## **GEOTECHNICAL INVESTIGATION & REPORT**

Proposed 55-Plus Building  
100, 108 & 114 Emma Street South  
Grand Valley, Ontario

Project Number: 17-1000A

Date Issued: September 23, 2019 (Rev.2)

Project			100, 108 & 114 Emma St. S., Grand Valley	
	Analysis Description			Existing Conditions	
	Drawn By	A. Winkelmann	Scale	1:400	Company
				Central Earth Engineering	
	Date	2017-12-10, 1:38:44 PM		File Name	Slope Analysis - Existing Conditions.slim

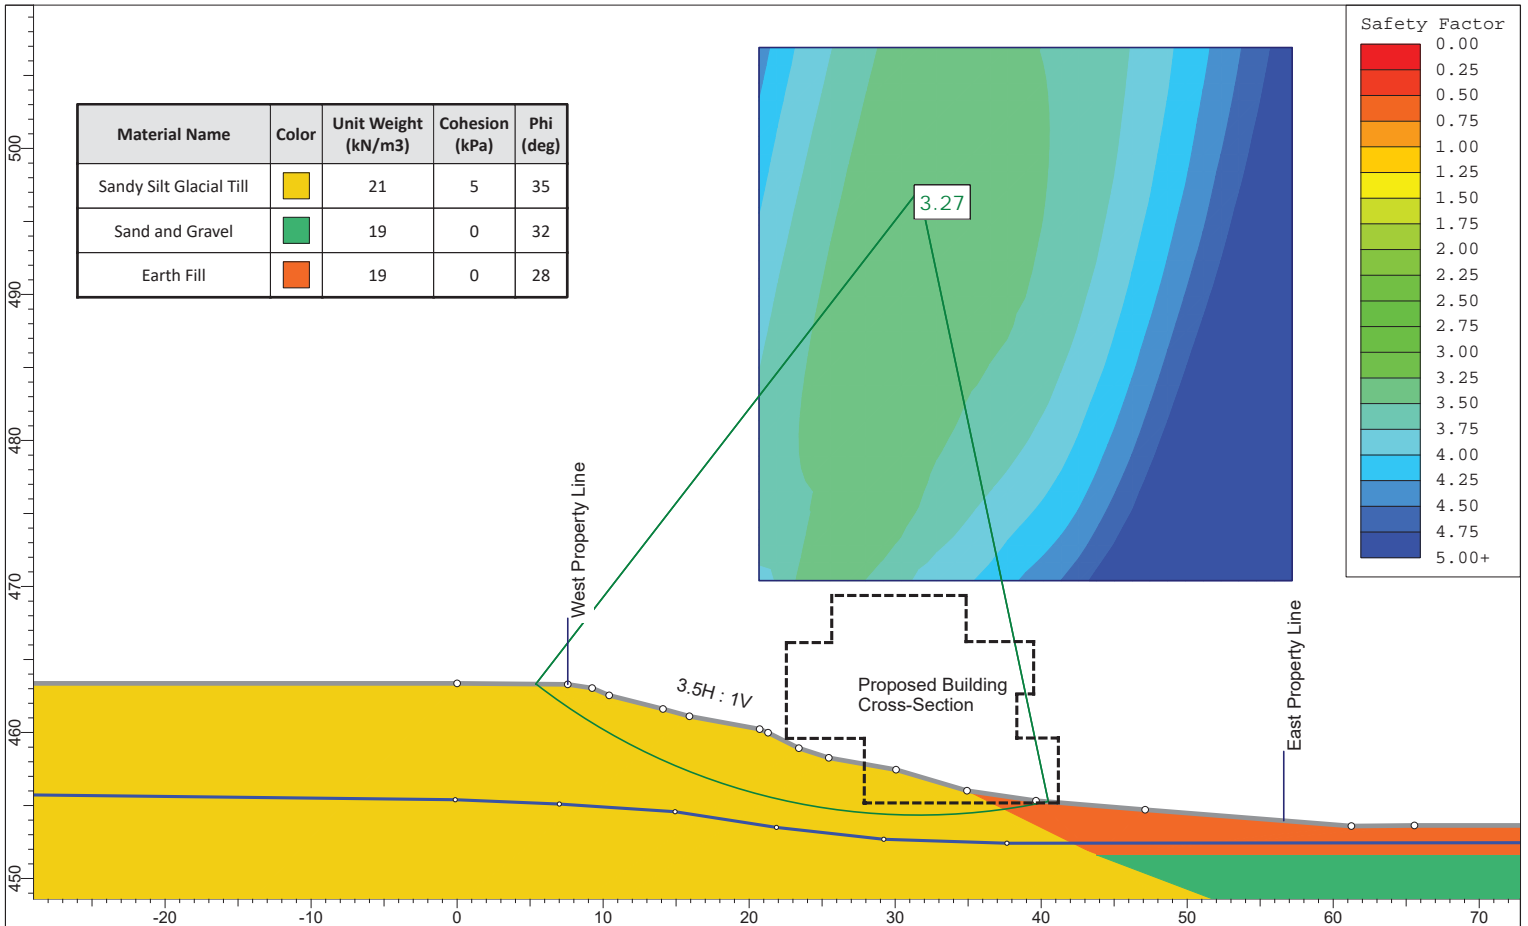
Note on Drawing: Geotech report notes 3.5:1 in Appendix B. Our typical max is 3:1. Geotech is to review proposed slopes. How is this being maintained? Based on the plans, only grass is proposed. How is the surface being stabilized after grading considering external drainage does appear to rundown this slope.

CEE Response: The 3.5:1 is in reference to the existing grading. Based on our review of the drawings, it is proposed to steepen the slope slightly to create a drainage swale which will redirect all surface water away from the building. In terms of slope stability, we can confirm that the inclinations proposed (as steep as 2.3H:1V) will have a factor of safety of at least 1.5, which is the regulatory factor of safety required, and is therefore acceptable. In terms of surface treatment of the slope, it is the responsibility of the civil designer to ensure that the slope surface is being adequately stabilized (e.g. with erosion control blankets/turf reinforcement mats, grasses, shrubs, live staking, etc.). This is imperative to ensure that surficial erosion does not occur which can cause detrimental effects to the neighbouring properties to the north.
